Appendix D

Technical Note

An Analysis of Errors and Omissions in the Dynamic Risk, Inc. Line 5 Alternatives Analysis, Option 5

Edward E. Timm, PhD, PE
5785 Deer Run Trail, Harbor Springs MI 49740
EdTimm@Gmail.com

Figure 1. Maximum Combined Stress for Line 5 as a Function of Current Velocity

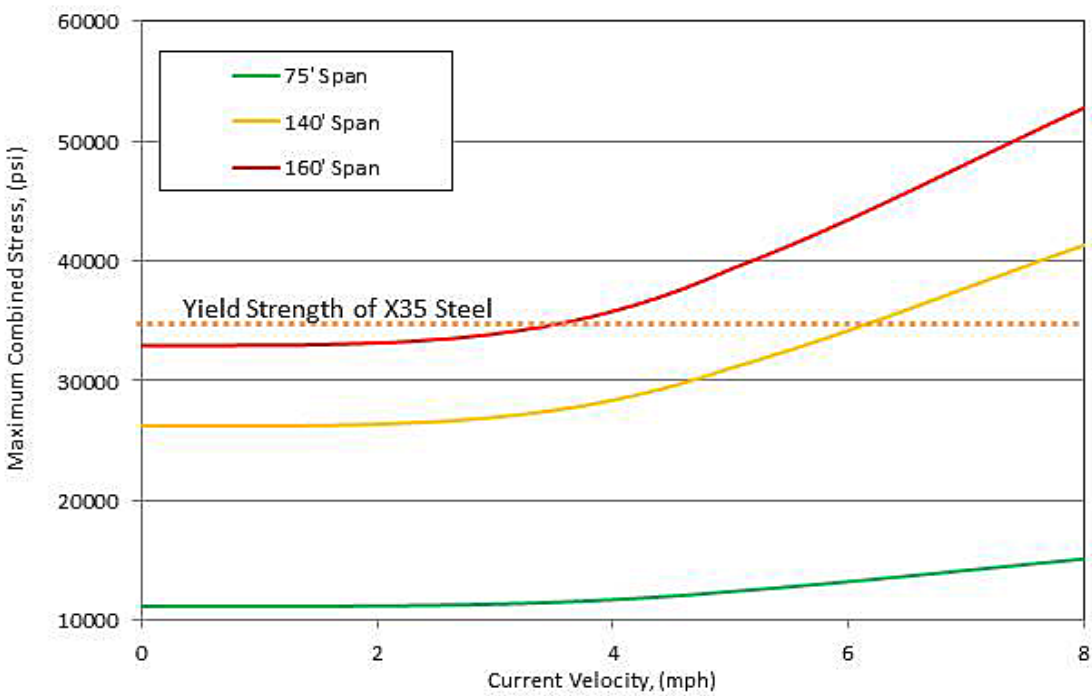
For these reasons, an accurate assessment of the rupture probability of the Straits sections of Line 5 depends on developing a good understanding of the fluid mechanical phenomena that characterize flow in the Straits. As thoroughly discussed in the Timm[4] report, flow in the Straits at any velocity beyond creeping flow is characterized as a developing mesoscale turbulent flow

similar to the flow fields found in the Gulf Stream or the Straits of Gibraltar. The flow is further complicated by the fact it is driven by weather systems that cross the Great Lakes basin in unpredictable ways. Since drag forces on the pipe respond to variations in flow velocity on the millisecond time scale, it is important to characterize maximum instantaneous flow velocities during extreme weather events to develop a realistic current velocity probability distribution for use in a Monte Carlo simulation of pipeline rupture risk. This task is yet further complicated by the fact that the turbulent flow in the Straits is far from homogeneous. Buoy ADCP data taken at differing locations in the Straits shows significant current velocity variation based on location as would be expected. Characterizing the flow field in the Straits using a single probability distribution for current velocity can only give an estimate of rupture risk that is biased low unless that distribution accurately includes the highest instantaneous velocities anywhere along the span of the pipeline.

Figure 2. Comparison of Measured and Predicted Current Velocity at NOAA Buoy 45175 along with Corresponding Meteorological Conditions

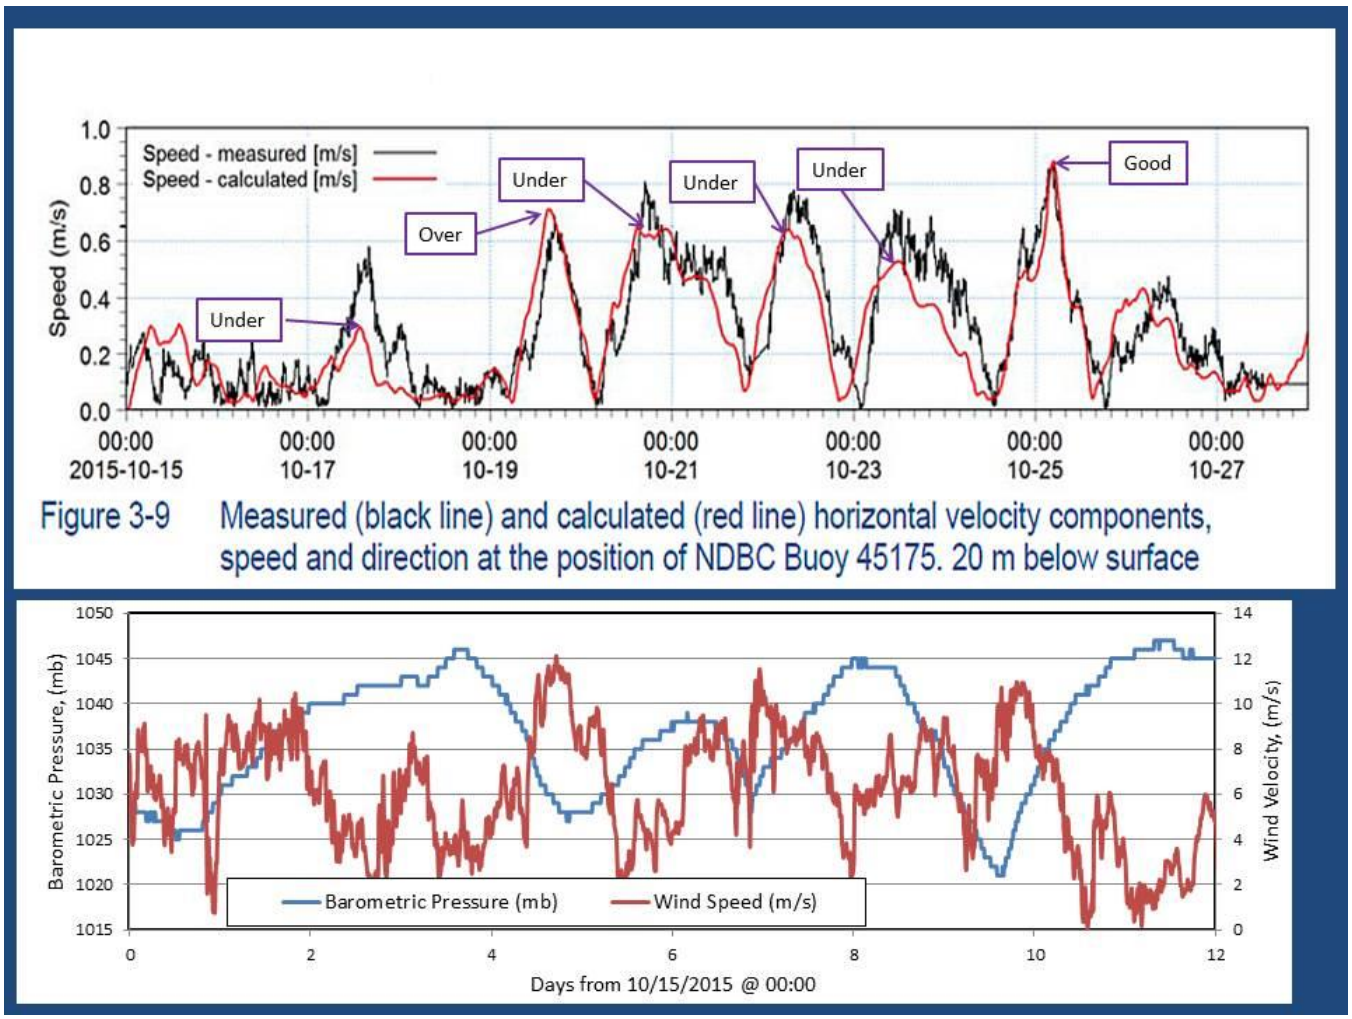
Figure 2 is an annotated comparison of velocity data taken over a twelve day period beginning October 15, 2015 at the -20 m level from NOAA Buoy 45175 with the predictions of the MIKE 3 model. On a separate plot, the wind speed and barometric pressure measured by Buoy 45175 during this period is depicted.

Figure 6 shows that while the MIKE 3 model predicts currents that generally correspond with the measured velocities, it fails to predict the critical peak current velocities necessary to predict maximum stresses on the pipe. Of the six current excursions depicted in Figure 2, one is correctly predicted, one is over-predicted by ~15%, three are under-predicted by ~20% and one is under-predicted by ~50%. The meteorological information shown on Figure 2 describes a period of generally moderate weather for October on the Great Lakes with high pressure and winds not exceeding 24 mph. Given that hydrodynamic forces on Line 5 generally scale with the square of current velocity, these predictions of peak current velocity are insufficiently robust to be the basis for examining the rupture risk of the single most critical oil pipeline in the

This decision by the unidentified "project team" (Dynamic Risk ?, DHI ?, Enbridge ?) to use meteorological forcing data from a period where "Wind conditions are fairly average compared to other years, without any particular high wind events or extreme situations." defies common sense. Even laity certainly understand that structures don't fail during nice weather! To exclude the very conditions that would be expected to lead to a rupture of Line 5 and then using the model output to attempt to predict rupture risk is a decision by the "project team" that is neither explained in the Alternatives Analysis nor realistic. The only explanation for this decision that occurs to this author is that the MIKE 3 model cannot be reasonably converged when faced with extreme but historical meteorological forcing conditions as would have been found with years like 1913, 1975 or other years memorable for very severe weather[14]. Regardless of the reasons for the decision to base the Alternatives Analysis on a year with only mild weather conditions, this decision alone makes the risk estimates for spanning and vortex induced vibration based failures extremely suspect.

Figure 3. Comparison of Measured and Predicted Significant Wave Height at NOAA Buoy 45175

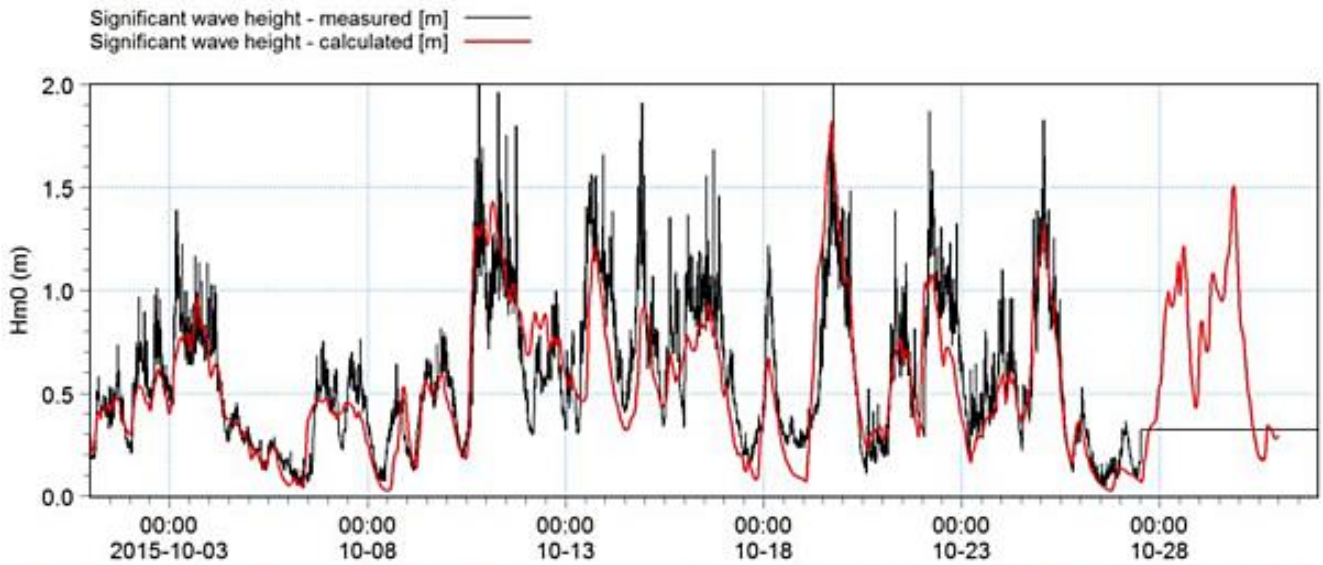
Similarly, it can be seen that the MIKE 2 hydrodynamic model, used to predict wave heights for the purpose of oil dispersion modeling, under-predicts wave heights during relatively benign October weather conditions. Figure 3 is reproduced from Appendix 5 of the Alternatives Analysis[15]. It too shows that the MIKE 2 model does a very poor job of predicting peak significant wave heights in conditions where the largest measured significant wave height is under two meters. Reference to the data available online from NOAA Buoy 45175[16] for October 10, 2015 at 19:40 shows a significant wave height of 2.509 m. This value is not reflected in Figure 3 which shows a predicted significant wave height of 1.3 m or about half of the actual value. This kind of disagreement between the model and actual measurement of peak wave heights makes relying on model predicted values instead of actual data likely to result in under-prediction of dispersion phenomena related to oil spill modeling. A likely cause of this misleading information from the MIKE 2 hydrodynamic model is the model is run with a maximum time step of 30 minutes while Buoy 45175 takes data every ten minutes. Once again, awareness of the averaging time used in model simulation and buoy measurements is necessary to prevent incorrect conclusions about the severity of extreme peak events from

being drawn based on information that does not have the time resolution necessary to expose extreme peaks.

Figure 4. Comparison of the Tail Risk as a Function of Current Velocity

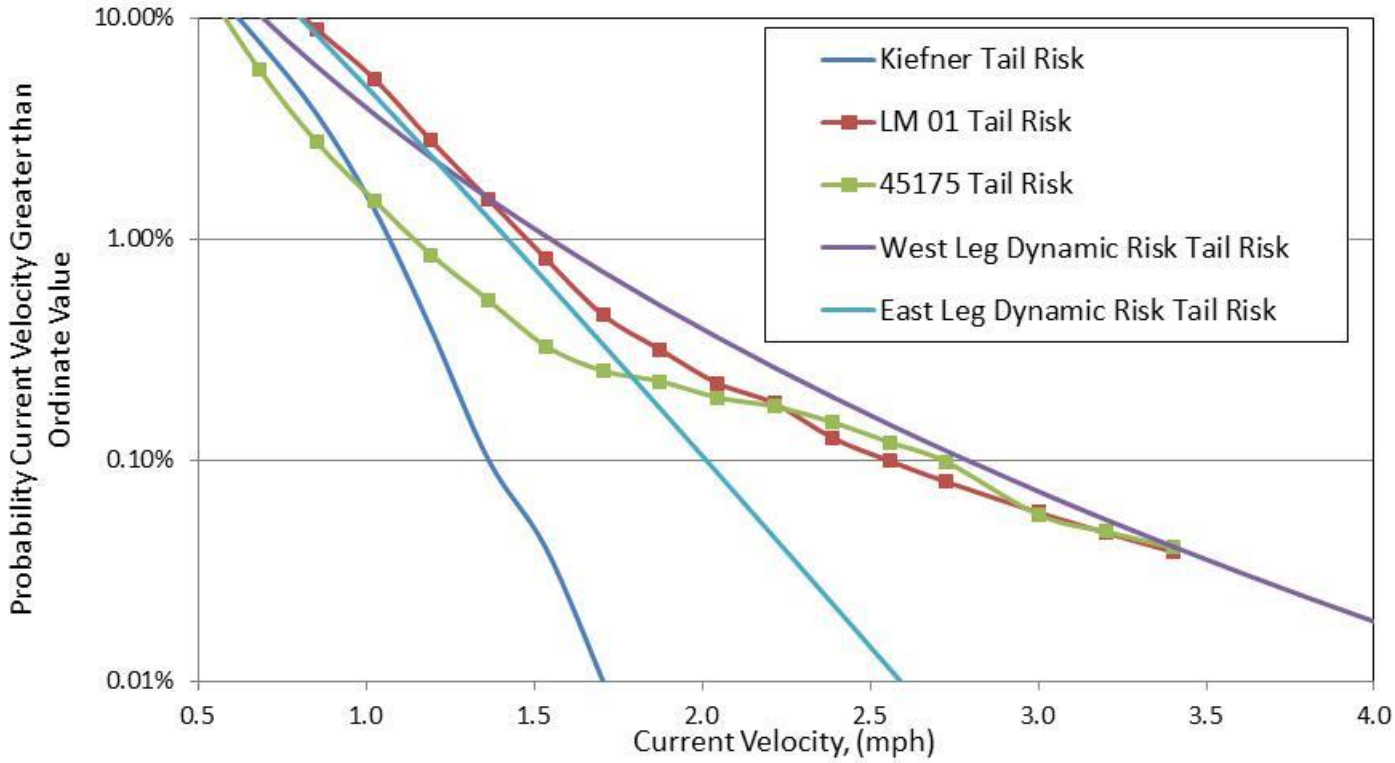
Since it is extreme values of the current velocity that will apply potentially damaging forces to the Straits segments of Line 5, a comparison of actual data with these calculated distributions in the upper tail region is warranted. Figure 4 is a cumulative probability plot of data taken from buoys 45175, LM 01 and the unreported measurements revealed in the Kiefner report with the current velocity fits resulting from the one year duration run of the MIKE 3 model. This figure shows that the tail risk for current velocity between data taken from Buoys 45175 and LM 01 is similar to the risk calculated from the MIKE 3 model for the West Leg of Line 5. The agreement between the buoy data and the MIKE 3 model for the East Leg as well as the Kiefner data is not nearly so impressive. Given that Buoys 45175 and LM 01 straddle the location of the pipeline, are placed in water of similar depths and give quite similar risk results;

the fact that the MIKE3 model gives very different tail risk for these two locations is puzzling. The Kiefner measurements are expected to predict lower velocities because they are apparently three hour average data as opposed to LM 01 which has a one hour averaging period and 45175 which has a ten minute averaging time.

Conversion of the information displayed in Figure 4 into the expected amount of time the current velocity exceeds the Bechtel design basis for Line 5 under the Straits gives a more obvious indication of how the design basis compares with measurement and modeling based results. It should be noted that none of the measured data comes from a particularly stormy year and the model output was specifically restricted to quiescent conditions due to the choice of meteorological forcing conditions.

Figure 6. Probability an Unsupported Span is Longer than Ordinate Value for East and West Legs of Line 5 for the Period 2005-2016

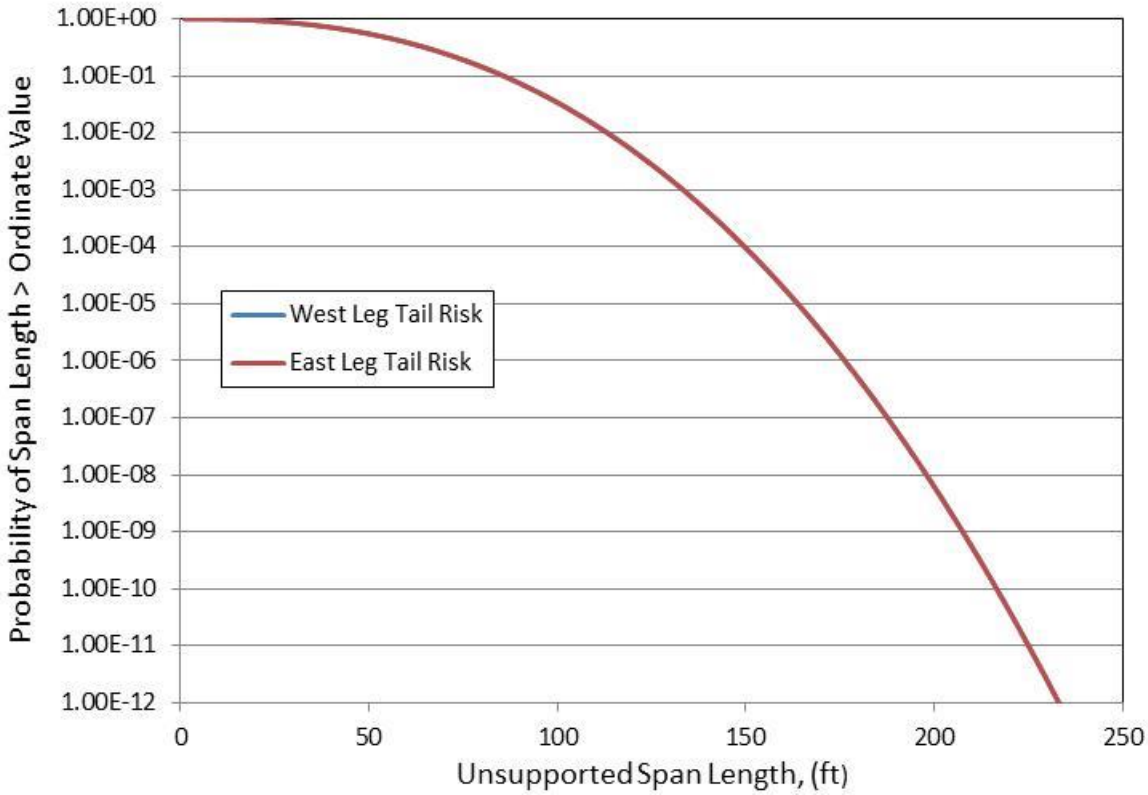
Figure 6 is a plot of the probability a span will be greater than a given length for both legs. At the scale of Figure 6, the fitted Weibull cumulative probability distributions appear to be identical.

These distributions are a very good fit to the span data revealed in Reference 21 but when used in a Monte Carlo analysis to estimate risk, the authors of the Alternatives Analysis appear to have made a serious mathematical error. The 715 East Leg span length measurements and the 691 West Leg span length measurements result from pooling data taken during inspections in 2005, 2006, 2007, 2010, 2012, 2014 and 2016. Each individual dataset contains a differing number of spans both because of new washouts and the addition of new supports. This means that while the distribution functions plotted above may be relatively time invariant over the period 2005-2016, the ensemble of spans existing during each time interval between inspections is different. Because a random selection of current velocity in the Monte Carlo impacts all the spans in an ensemble, each span in that ensemble must be tested for the failure criteria not just one randomly selected span. Because extreme current events are quite rare but each such event tests a large number of spans, multiple failures may occur for each

random current velocity selection. **This physical fact results in a much larger number of failures than the Monte Carlo implementation apparently done in the Alternatives Analysis and the estimates of risk derived from this analysis are erroneously underestimated by a large margin!** This problem affects both the spanning risk Monte Carlo and the vortex induced vibration Monte Carlo analysis

Figure 7. Overlay of Pipe Deformation Information from the 2016 Baker-Hughes Geopig Inspection on Figure 5 from the Biota Report.

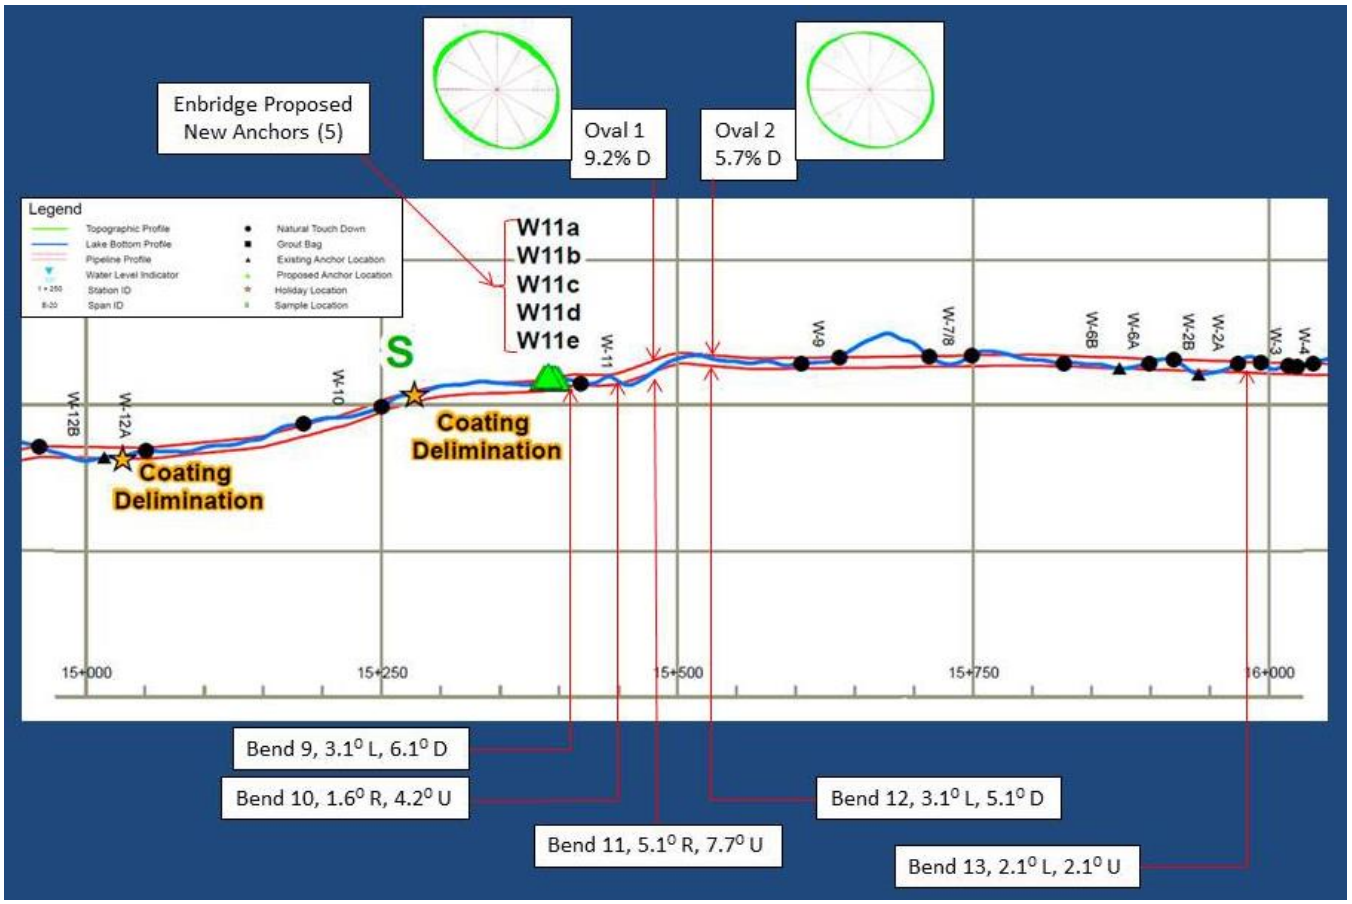
The Alternatives Analysis states that the bends found in the exposed underwater sections of the pipe (Bends 10 and 11 in the East Leg, Bends 9 through 13 on the West Leg) are of unknown origin but "may have been intentionally or unintentionally created as part of the installation process." This statement is speculation on the part of the authors of the Alternatives Analysis and potential evidence of damage should not be dismissed without a full examination of the evidence.

Information from three sources has been pooled in order to investigate the cause of damage to the exposed lakebed portion of the West Leg of Line 5. Figure 7 is a composite drawing of the area where Bends 9-13 are located. The 2016 profile view of this section of the pipe is taken from Figure 5 in the Biota[26] report, the 1979 profile view[20] was released by the Michigan Pipeline Task Force and the geometric inspection information is taken from the 2013 Baker-Hughes Geopig[27] geometry inspection report. Figure 7 shows the locations of the five bends and two ovals found by Baker-Hughes on the bottom profile view taken from the Biota report. Four of these bends are within a 250' section of pipe and the two ovals are both the result of bending as shown by their coincidence with Bends 11 and 12. Both ovals have primary axes that do not coincide with the vertical direction and all bends have a lateral component as well as a vertical component. These features are not consistent with "sag bends" that form as a pipeline is sagged into place along a poorly graded path but rather appear to have been bent both vertically and laterally which is what would be expected if they had been formed by the combined forces of gravity and currents. It is exceedingly unlikely that these bends were formed during construction since the pipe was pulled along the bottom of the Straits using great force, a process that would insure a straight path. These bends are not mentioned on the 1979 profile drawing of the pipe which includes many notes about the condition of the pipe at that date.

A more probable explanation than the one given in the Alternatives Analysis for the existence of these features can be found in Figure 8. In Figure 8, the top drawing is the 2016 bottom profile which has been flipped end to end so that south side of the Straits is oriented to the left similarly to the 1979 profile drawing. Both profile drawings have been stretched horizontally and vertically so that they are scaled similarly. Additionally, using the 1953 Lake Michigan water level datum of 581 feet elevation allows depths to be compared and the 70' depth level is plotted on both profiles. The profile drawings have been offset to compensate for the differences between the Bechtel chainage length scale used in 1979 and the absolute length scale used in 2016.

placed prophylactically to prevent ongoing washouts from growing into excessive spans. As can be seen from Figure 7, five of these supports (W11a-W11e) are to be placed in the area of the pipe where bends and ovals exist. Enbridge's support permit application makes no exceptional mention of these supports in their support permit request. A clip from a recent Enbridge spreadsheet that details the span history of Line 5 provides some detail on the W11 span and is shown as Table 5.

Figure 8. Comparison of West Leg, South End Lake Bottom Profile Drawings from 1979 and 2016

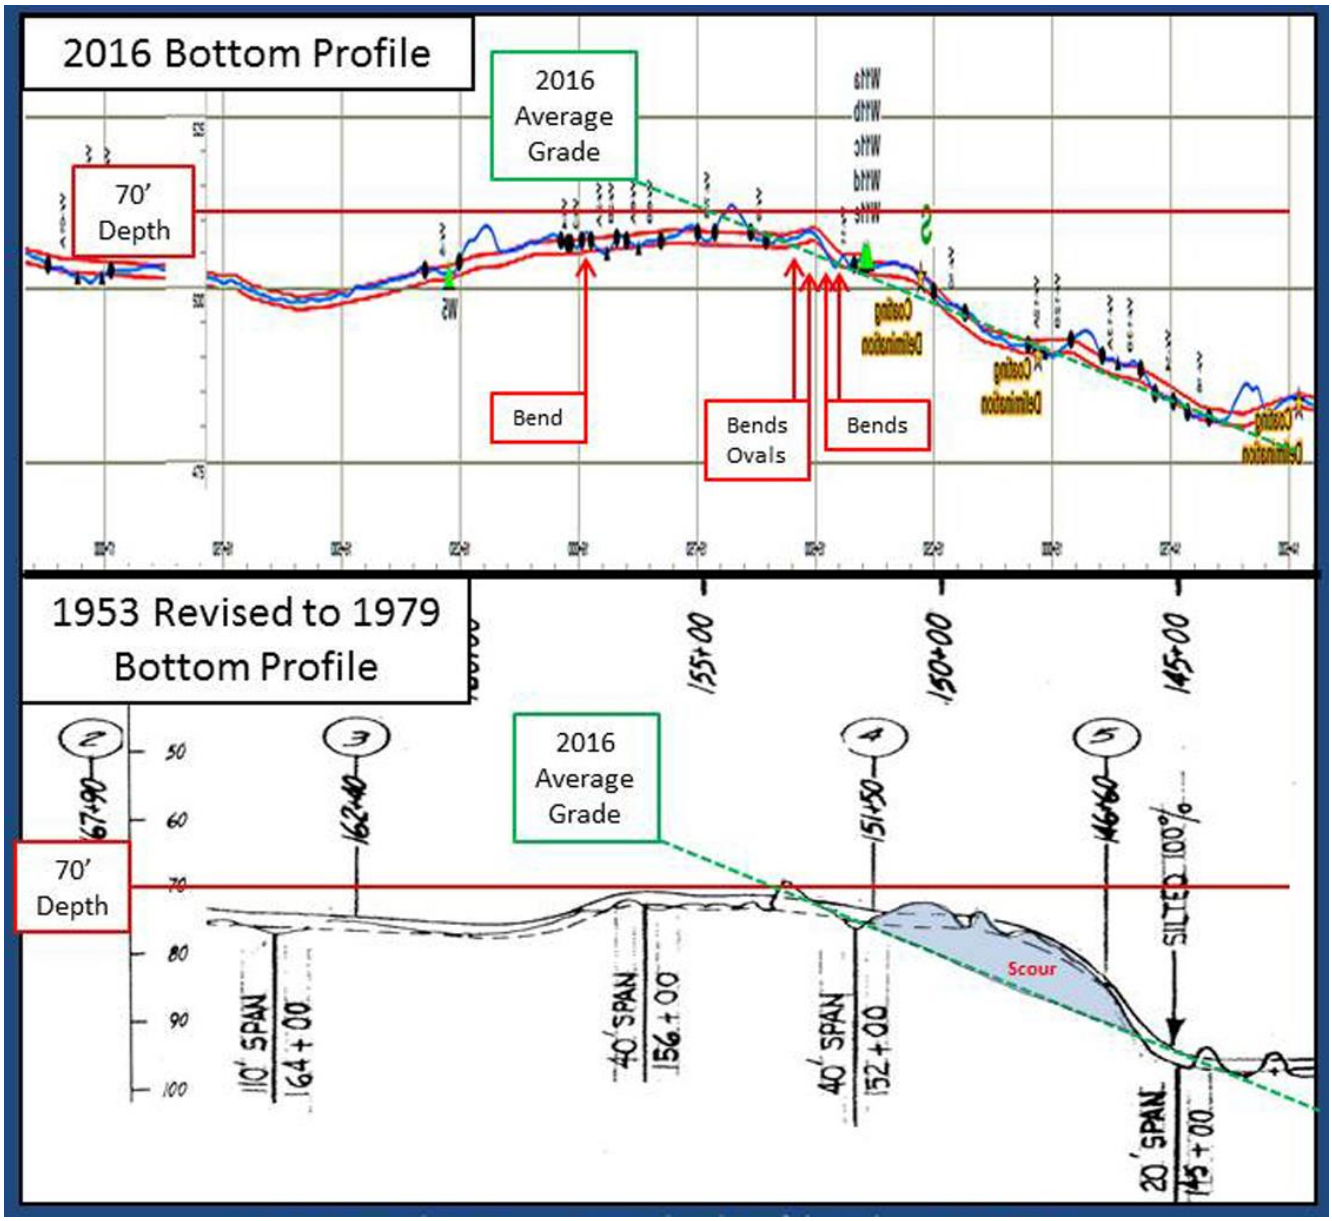
The green dotted line on the 2016 profile drawing labelled "2016 Average Grade" has been carefully transferred to the 1979 profile drawing. The light blue area marked "Scour" on the 1979 drawing shows the volume of bottomland that appears to have been scoured away between 1979 and 2016. The obvious interpretation of Figure 8 is that the washouts noted in the 1979 drawing appear to have merged into one long span (~300 feet) sufficiently long to have caused the pipe to collapse to the bottom profile shown in 2016 bending it and ovaling it in the process.
